**Subject:** info and action: Transmittal of NRC comments and Slides Regarding August 3, 2021, Version of Industry's TICAP Guidance Document  
**Sent Date:** 8/13/2021 1:17:34 PM  
**Received Date:** 8/13/2021 1:17:00 PM  
**From:** Sebrosky, Joseph

# Technology Inclusive Content of Application Project Public Meeting

**Draft Report Revision E  
Issued for Nuclear Regulatory Commission Review and Comment**

Figure 3.4.N-2. Core Temperature

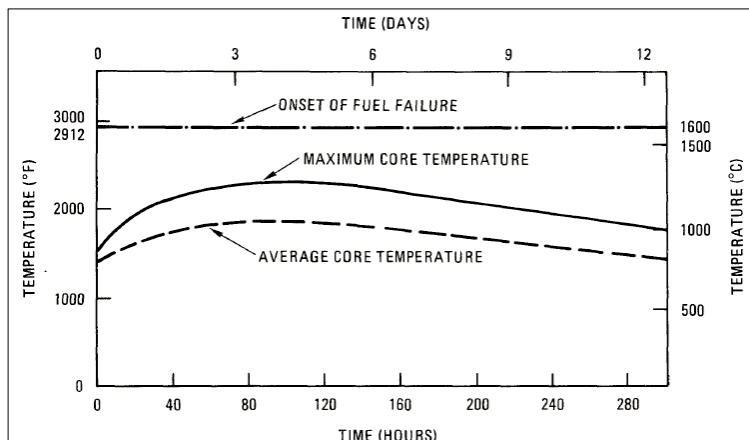
**Commented [A116]:** Remain subcritical?

**Commented [A117]:** Values? Time?
